SUNDRY NOTICES AND REPORTS ON WELLS
Do not use this form for proposals to drill or to re-enter an abandoned well. Use form 3160-3 (APD) for such proposals.

Cimarex respectfully requests approval to plug back the Trinity 20 Federal Com 1 Well according to the following procedure.

Cimarex Energy - Trinity 20 Federal Com 1 Recompletion

Trinity 20 Federal Com 1
30-015-34521
Cimarex Energy Company of Colorado
July 22, 2014
Conditions of Approval

PROPOSED

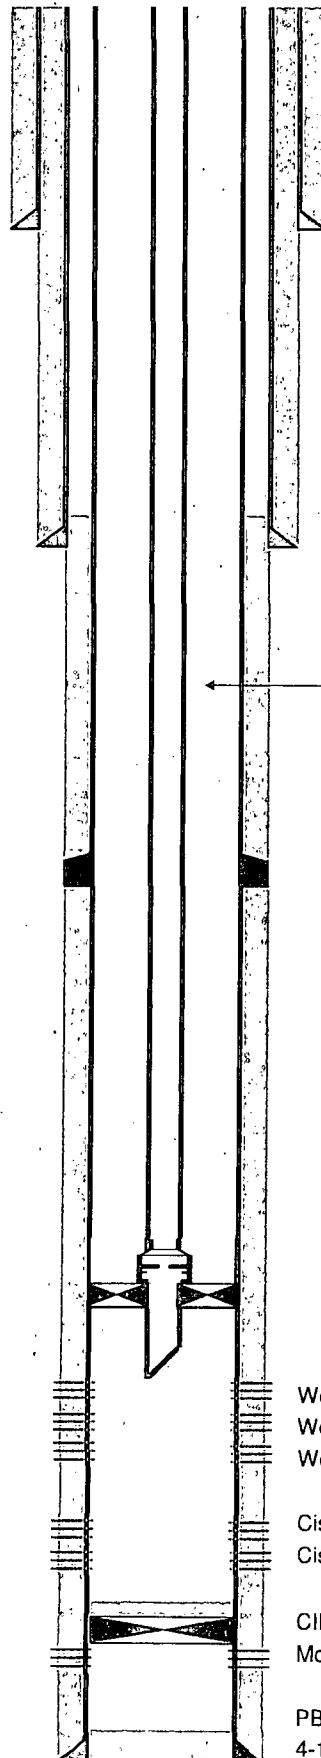
- 1. Operator shall set a CIBP at 11,451' and place 40sx Class H cement on top. Tag required at a minimum of 11,082' to ensure the top of the Morrow is covered.**
- 2. Must conduct a casing integrity test before any perforating or fracturing can be done. Submit results to BLM. The CIT is to be performed on the production casing to max treating pressure. Contact the BLM if test fails.**
- 3. Operator is approved to only produce from the Cisco Canyon formation. No DHC shall be done without approval from both the BLM and the State.**
- 4. Operator shall produce solely from the Cisco Canyon formation in order to establish a typical decline curve obtain reservoir data and submit results to the BLM for future DHC review.**
